RENESAS TECHNICAL UPDATE

Product Category	MPU & MCU	Document No.	TN-RX*-A113A/E	Rev.	1.00
Title	Corrections to Descriptions for the Flash Memory in the RX110 Group User's Manual		Information Category	Technical Notification	
Applicable Product	RX110 Group	Lot No.	Reference Document	RX110 Group User's Manual: Hardware Rev.1.00 (R01UH0421EJ0100) Specification Changes to the RX110 Group (TN-RX*-A112A/E)	
		All

This document describes corrections to 31. Flash Memory in RX110 Group User's Manual: Hardware Rev.1.00.

Figure 31.xx Procedure for Forced Stop of Software Commands

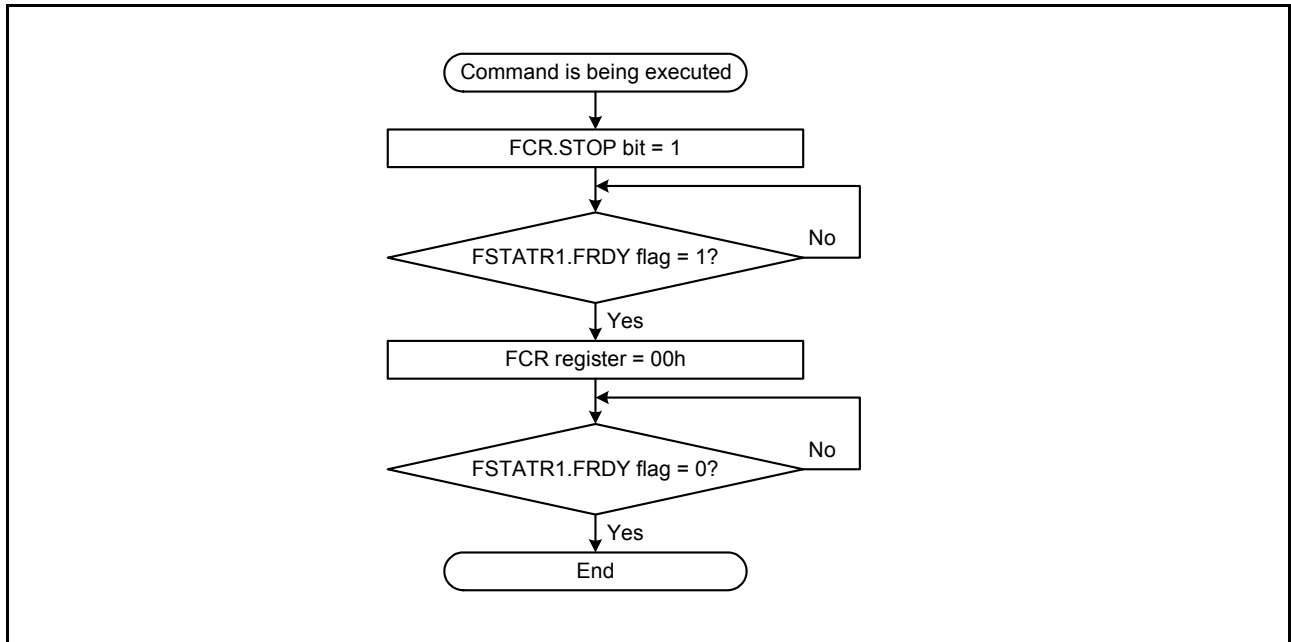
The following descriptions and flowchart are added to 31.6.4.6 Forced Stop of Software Commands.

Perform the procedure shown in Figure 31.xx to forcibly stop the blank check command or block erase command. When the command processing is forcibly stopped, registers FEAMH and FEAML store the address at the time of the forced stop. For blank check, the stopped processing can be continued by copying the FEAMH and FEAML register values to registers FSARH and FSARL.

Figure 31.18 Data Format for Bit Rate Automatic Adjustment

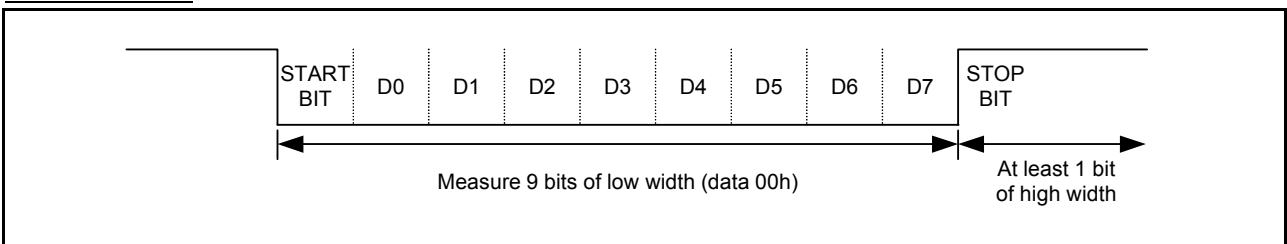
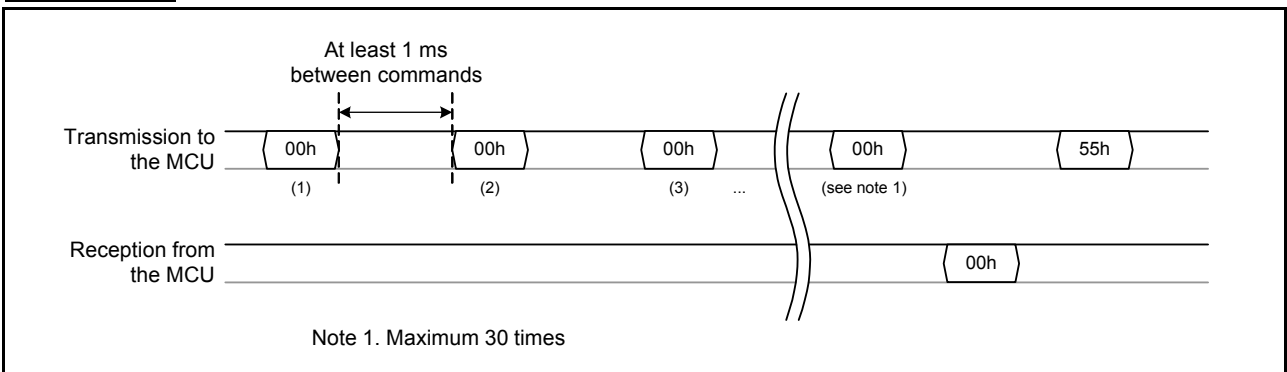
Figure 31.18 in 31.9.10.1 Bit Rate Automatic Adjustment Procedure is corrected as follows:

Note 1. Maximum 30 times

Figure 31.18 Transmit/Receive Data for Bit Rate Automatic Adjustment

Figure 31.20 Procedure to Send Inquiry Commands

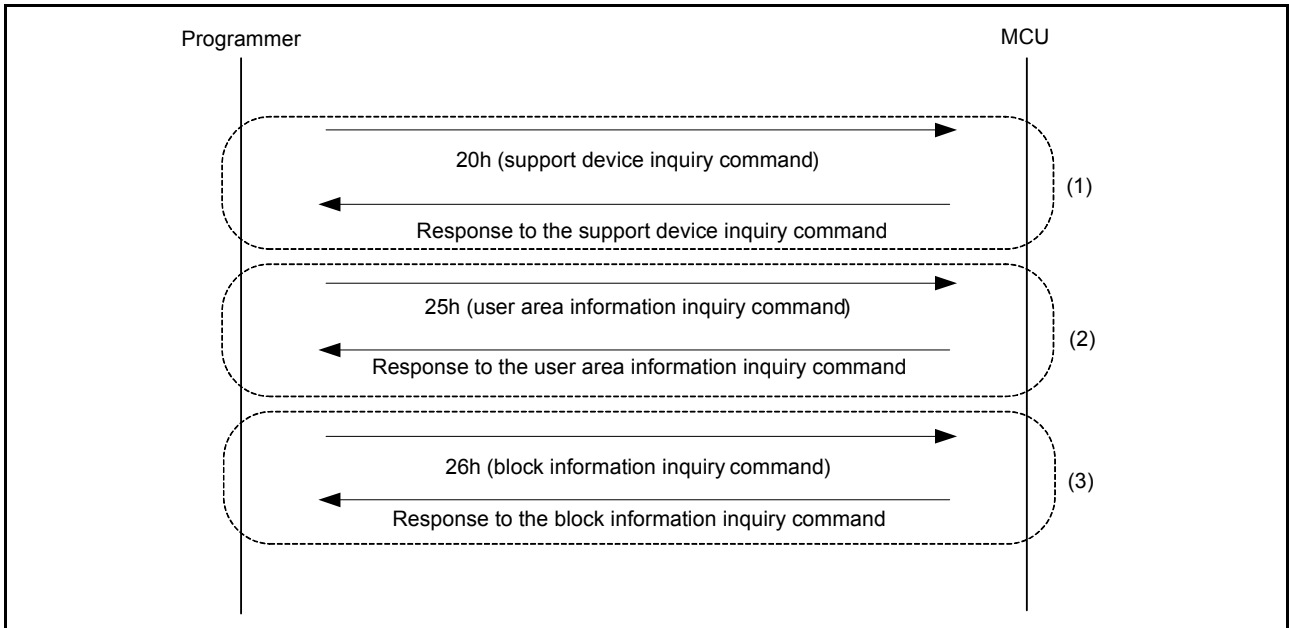
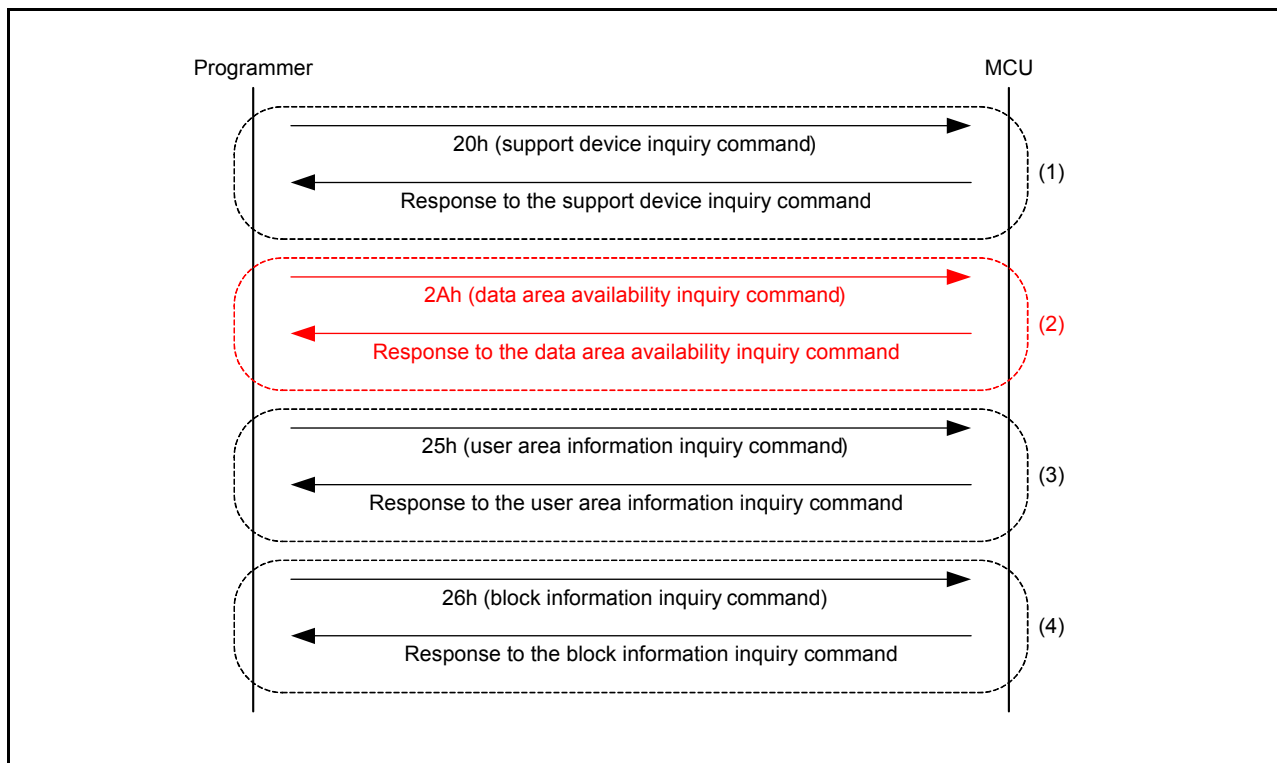
The procedure in 31.9.10.2 Procedure to Receive the MCU Information is corrected as follows:

- (1) Send a support device inquiry command (20h) to check which device to connect. The MCU returns the device code and series name.
- (2) Send a data area availability inquiry command (2Ah) to check the availability of data area and area protection. The MCU returns the availability of data area and area protection.
- (3) Send a user area information inquiry command (25h) to check the start and end addresses of the user area. The MCU returns the start and end addresses of the user area.
- (4) Send a block information inquiry command (26h) to check the block configuration. The MCU returns the start address, the size of one block, and the number of blocks for the user area.

Figure 31.21 Procedure to Select the Device and Change the Bit Rate

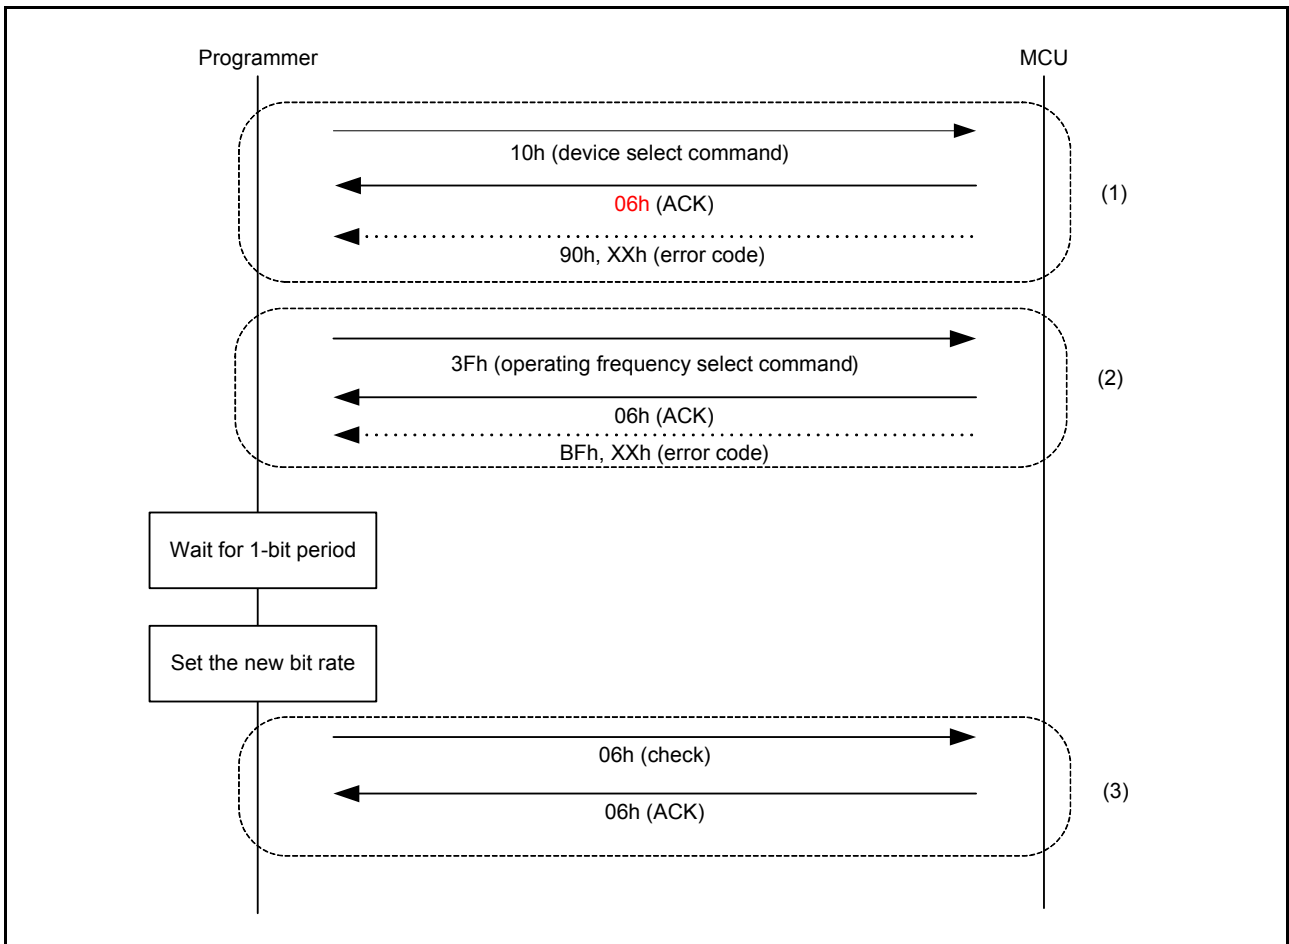
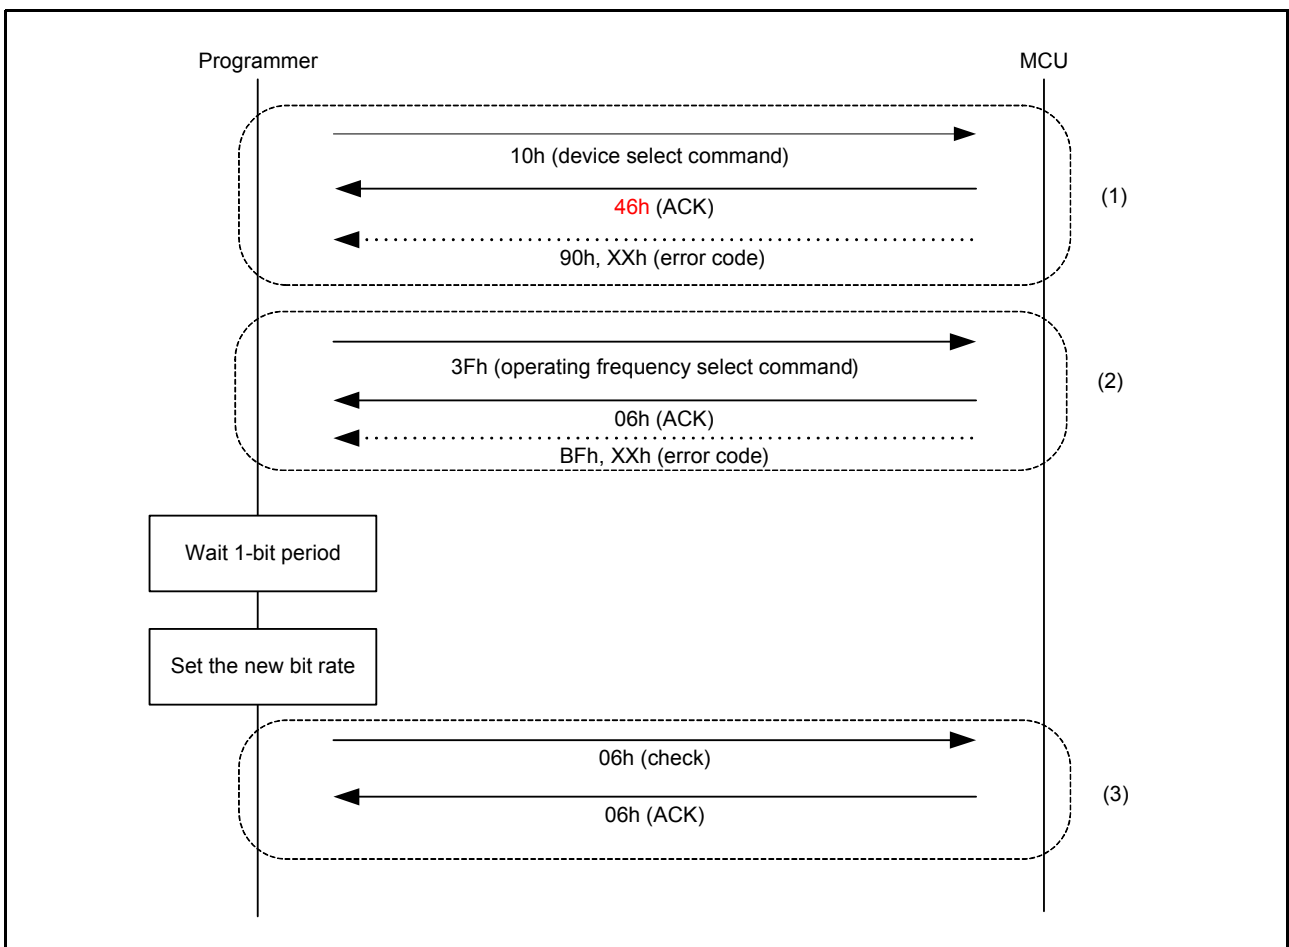
The procedure in 31.9.10.3 Procedure to Select the Device and Change the Bit Rate is corrected as follows:

- (1) Send the device select command (10h) to select the device to connect with the programmer and the endian of data that is programmed. When the program data is little endian, select the same device code as that for little endian in the response to the support device inquiry command. When the program data is big endian, select the same device code as that for big endian in the response to the support device inquiry command. When the device is selected successfully, the MCU sends a response (46h). When the MCU fails to receive, the MCU sends an error response (90h).

- (3) When the MCU receives a response (06h), the MCU waits for 1-bit period at the bit rate for sending the operating frequency select command, and then set the bit rate of the programmer to the changed value. After that, the MCU sends communication confirmation data (06h) at the changed bit rate. When the MCU receives the command successfully, the programmer sends a response (06h) of the communication confirmation data.

Figure 31.24 Procedure to Send Commands in Erase Ready Operation

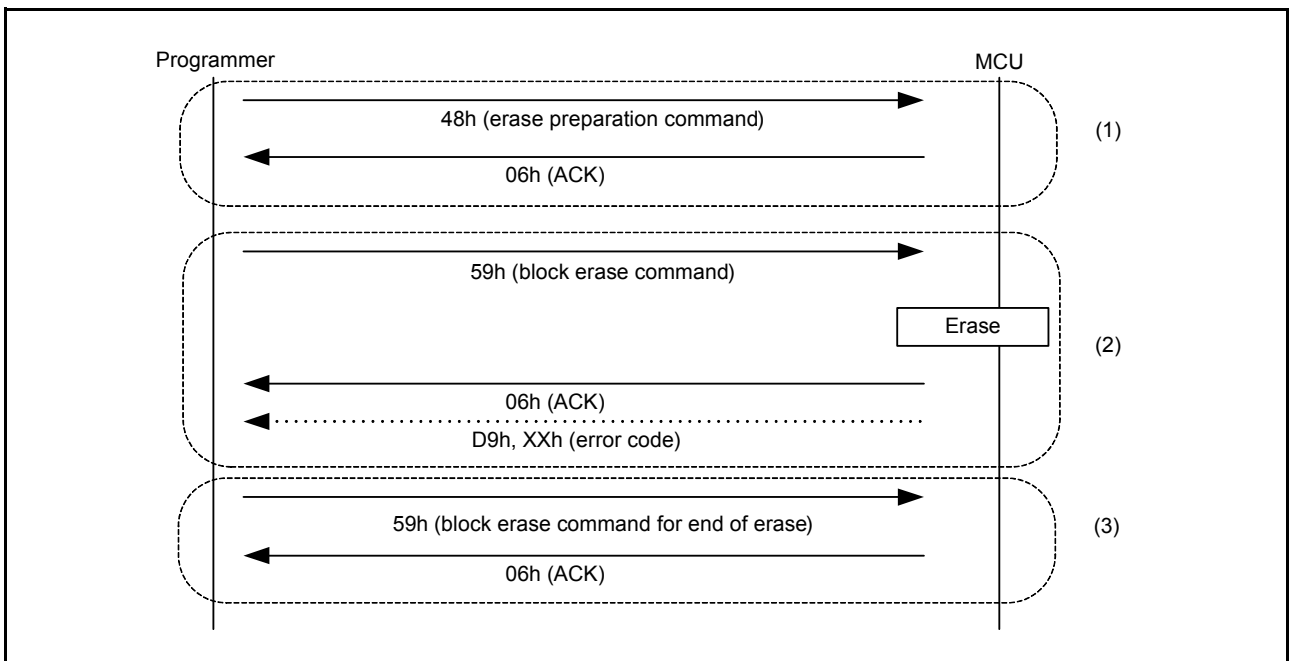
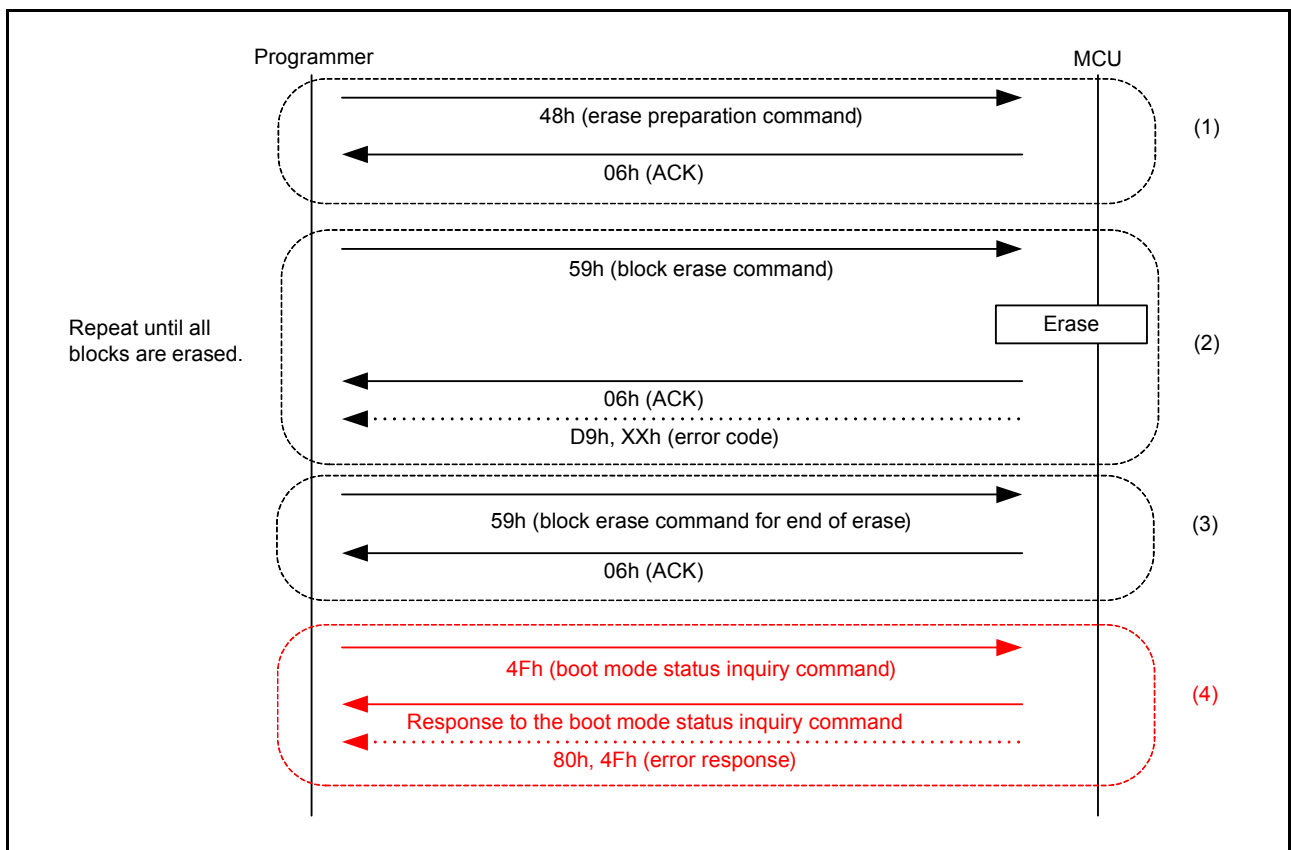
The procedure in 31.9.10.6 Erase Ready Operation and Change is corrected as follows:

- (3) **In order to place the MCU in the program/erase state**, send a block erase command for end of erase (59h 04h FFh FFh FFh FFh A7h). The MCU **enters the program/erase state and** sends a response (06h).

- (3) Send a block erase command for end of erase (59h 04h FFh FFh FFh A7h). The MCU sends a response (06h).
- (4) To confirm whether erase ready operation has ended, send a boot mode status inquiry command (4Fh). The MCU sends a response to the boot mode status inquiry command when erase ready operation has ended. If erase ready operation has not ended, the MCU sends an error response (80h 4Fh). If the programmer receives an error response, restart the MCU in boot mode, and start again from section 31.9.10.1, Bit Rate Automatic Adjustment Procedure.

Figure 31.29 Self-Programming Overview

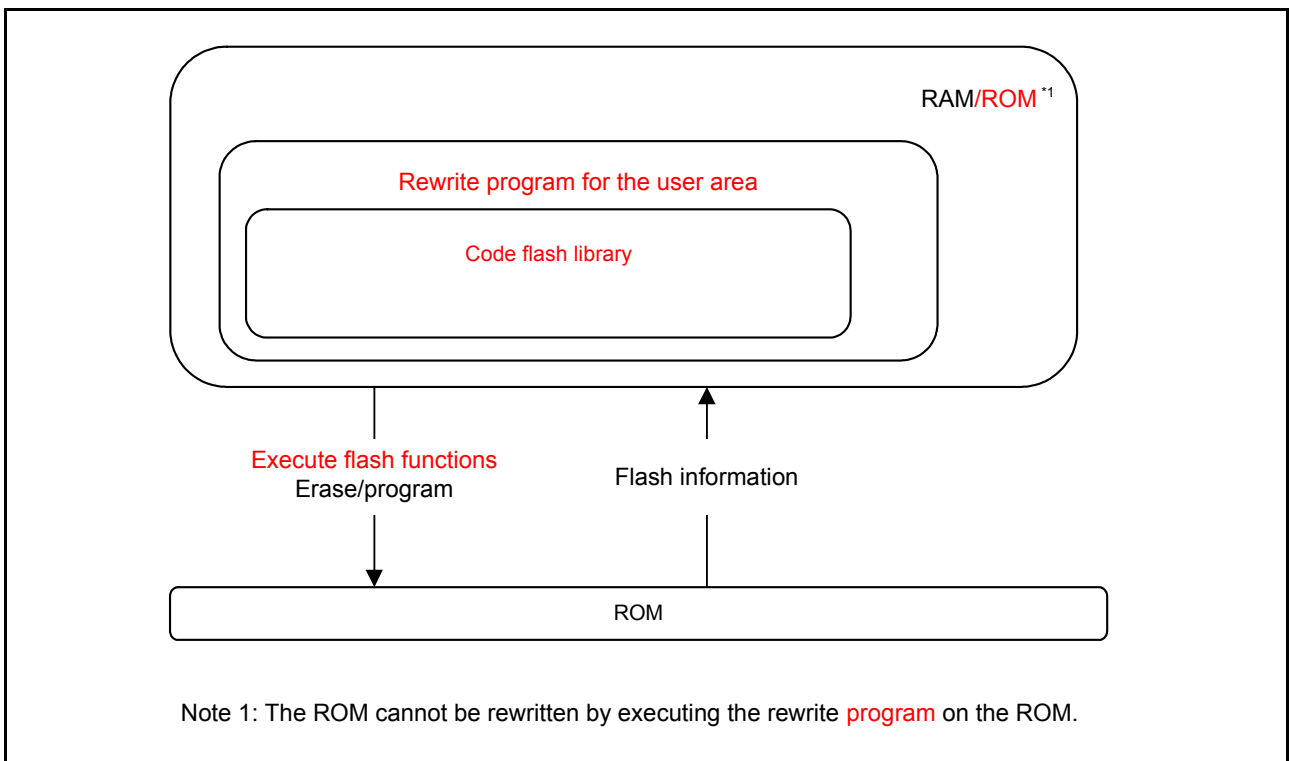
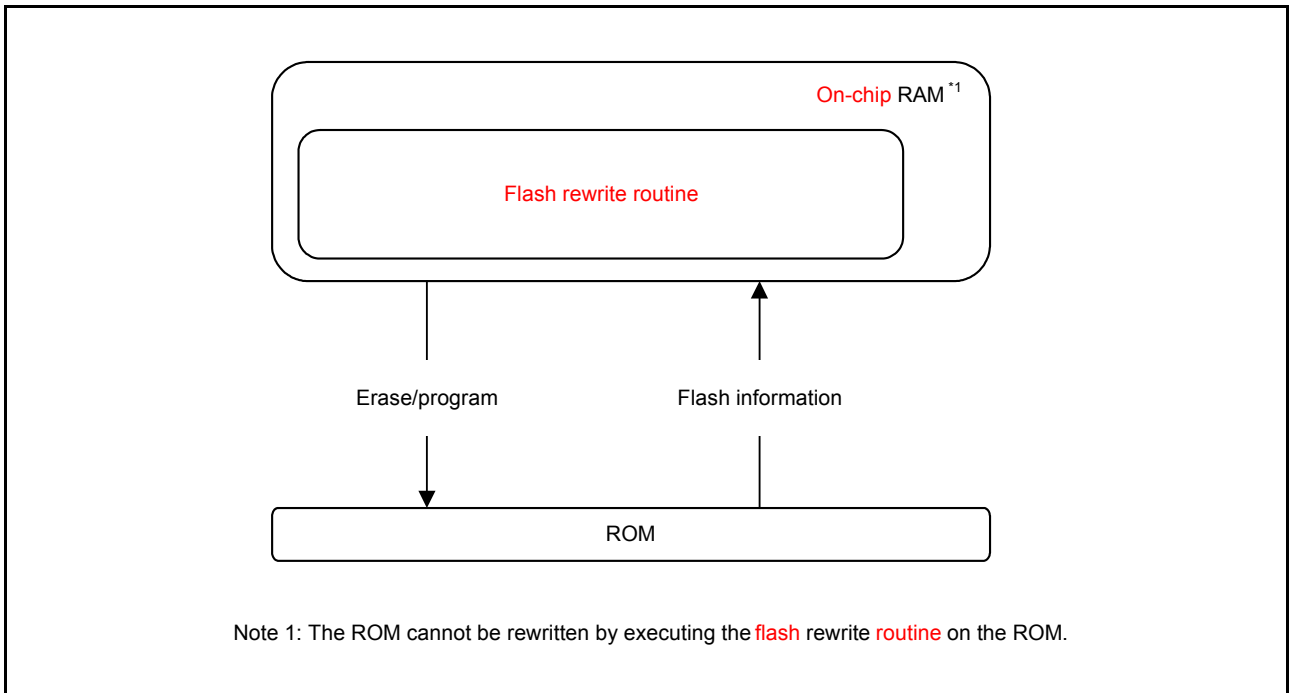
Descriptions in 31.10.1 Overview of 31.10 Rewriting by Self-Programming and Figure 31.29 are corrected as follows:

The MCU supports rewriting the flash memory by the user program. **Using the self-programming library provided from Renesas Electronics**, the ROM can be rewritten.

The MCU supports rewriting the flash memory by the user program. The ROM can be rewritten by preparing a routine to rewrite the flash memory (flash rewrite routine) in the user program.
